ASSESSMENT REPORT

Ravensworth Underground Mine Section 96(1A) Modification

Figure 2: Location of the Proposed Modifications

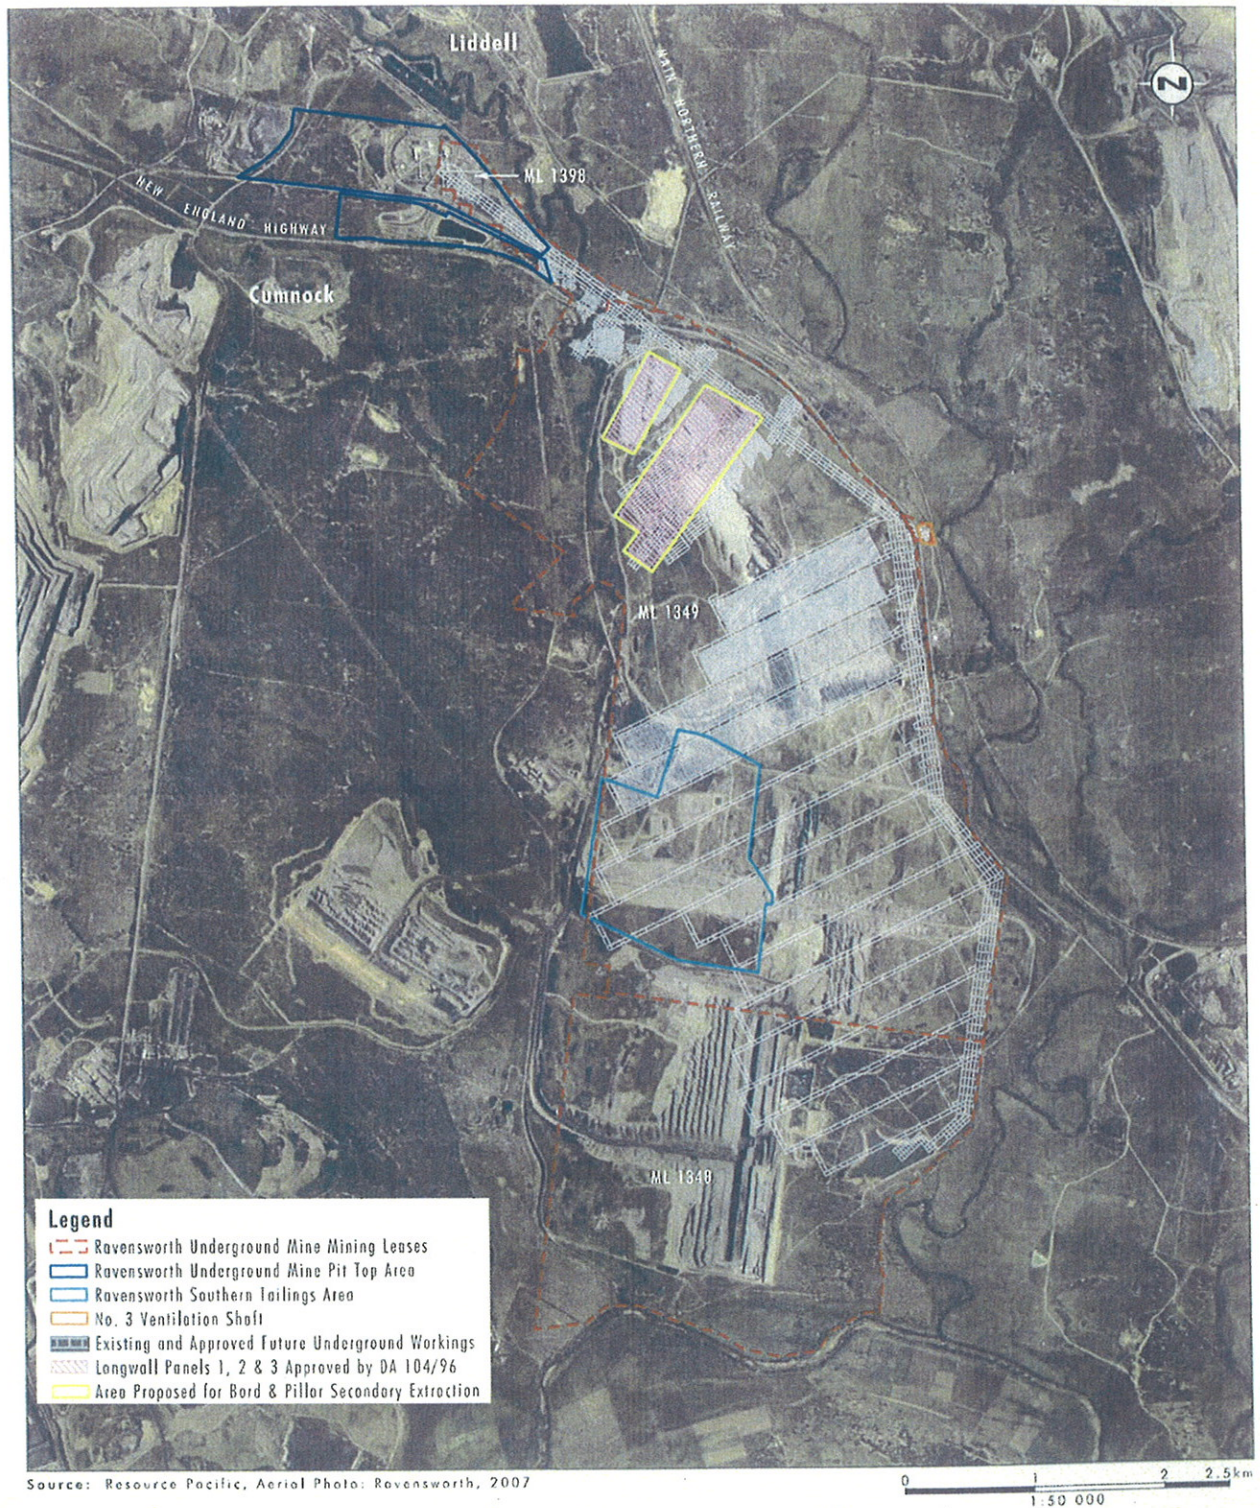
- change of mining method within an approved longwall extraction area (Longwalls 1-3) to bord and pillar mining;
- alterations to the current water management system including the:

- adaption of an existing pipeline between the nearby Cumnock Coal Mine and RUM to allow for the transfer of water between them;
 - establishment of a new pipeline to connect the water management systems for RUM and the nearby Narama Coal Mine (see Figure 3);

- development of a new water management plan.
- ability to transfer tailings and coarse reject to surrounding Xstrata mining operations;
- integration of environmental monitoring with surrounding Xstrata mining operations;

- realignment of a vent fan evasee from upright to a lower angle;
- installation of lighting on the run-of-mine coal stockpile; and
- approval for continued use of existing infrastructure.

Figure 3: Location of the Proposed Water Pipeline

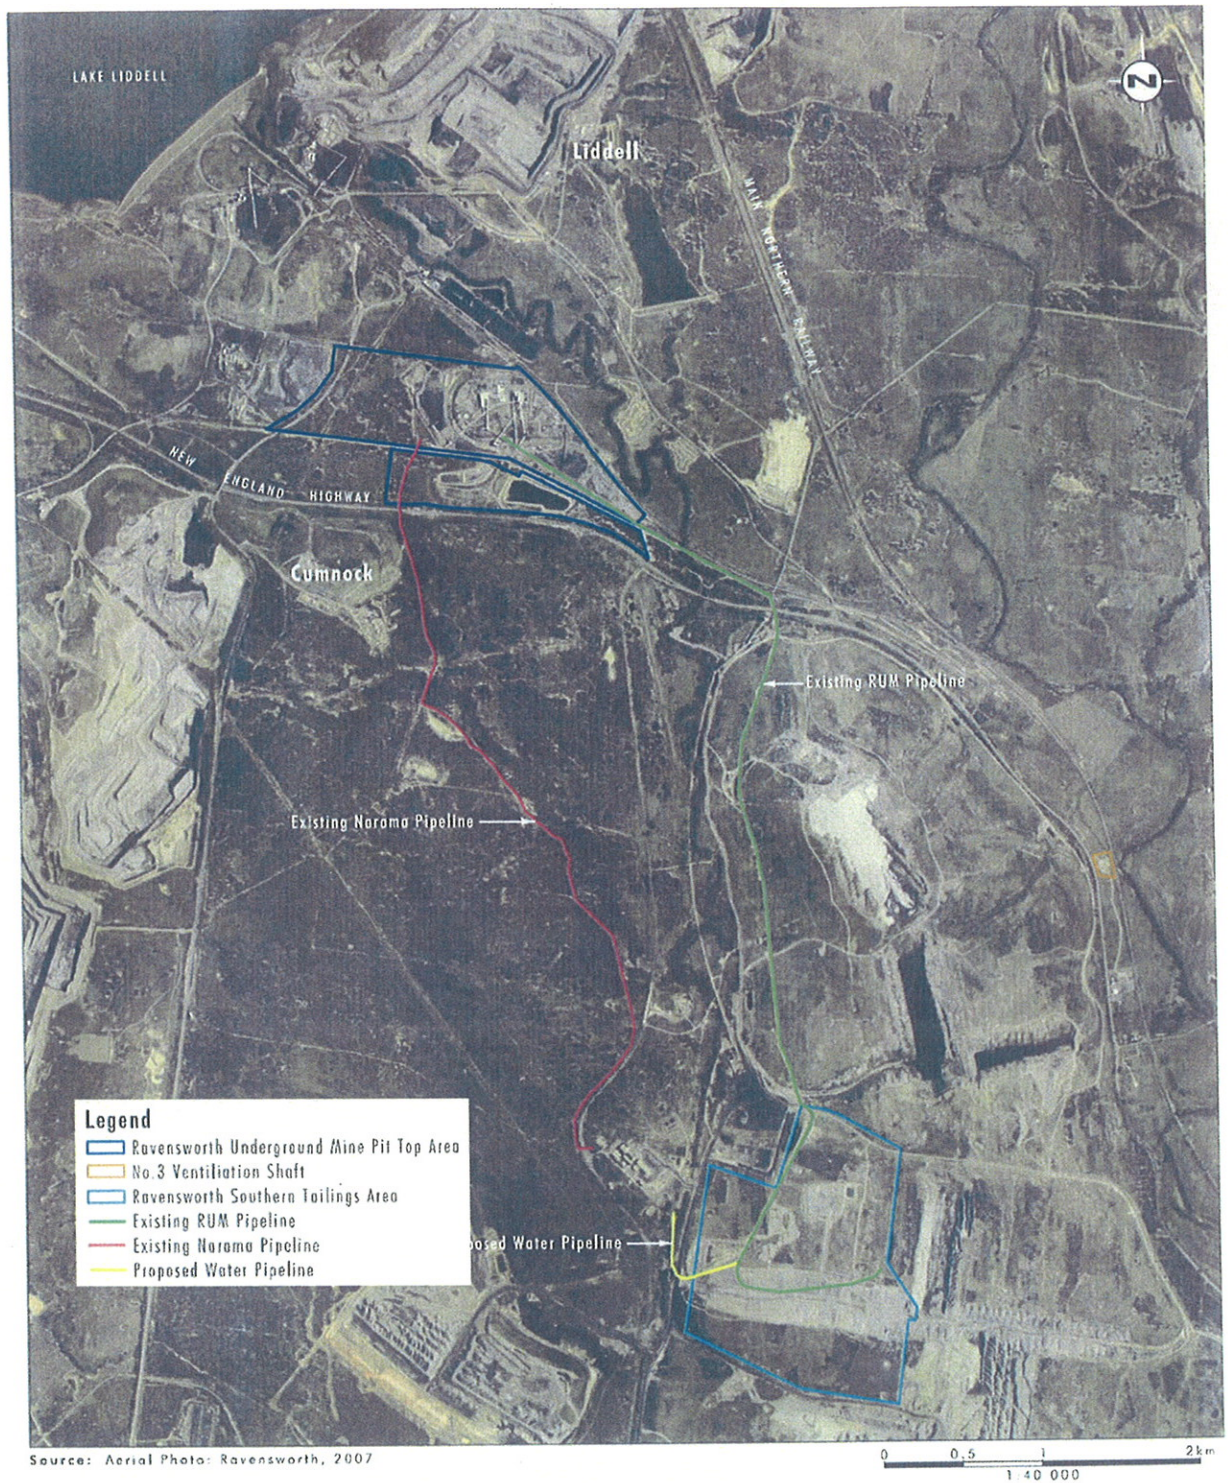
<i>Surface Water</i>	- Xstrata proposes to revise RUM's current water management system to integrate it with Xstrata's Greater Ravensworth Water Sharing System. Xstrata proposes to modify an existing pipeline and construct a new pipeline to enable connection of an existing RUM pipeline to the Narama water management system (see Figure 3). - The proposed modification to the existing pipeline involves the installation of flow meters to allow it to be used for water transfer, but would not involve surface disturbance of undisturbed areas. The proposed new pipeline would be 0.8 km long and located on previously disturbed land. - Xstrata has previously undertaken a number of upgrades to the water management system including equipment upgrades and a review of the operating system which incorporated a change to past storage practices, however, presently RUM does not have the ability to transfer water off-site. - DWE recommended a requirement for the mine to implement a surface and groundwater response plan in order to offset any unpredicted impacts to surface or groundwater resources. DECC raised concerns over the ability of RUM to prevent potential future uncontrolled saline water discharges. - In its response, Xstrata agreed to incorporate a surface and groundwater response plan in the revised Water Management Plan for the site. Xstrata noted that the proposal would enable water to be removed from the RUM water management system during and after significant rainfall events, enabling the appropriate storage capacity to be retained within the system and reduce the risk of uncontrolled saline water discharges occurring. - Xstrata also noted that the proposal would minimise the requirement for RUM to discharge mine water and import fresh water, by sharing water across nearby Xstrata mine sites, thereby minimising RUM's impact on surface water resources.	- The Department is satisfied the proposed modification to water management would enable more efficient use of this resource across Xstrata operations and that the proposal is unlikely to have any significant impacts on surface water resources. - Nevertheless, the Department has recommended a suite of contemporary water management conditions, which require Xstrata to implement a Site Water Management Plan in consultation with DECC, DWE and DPI, to enable the effective management and monitoring of RUM's integrated water management system.
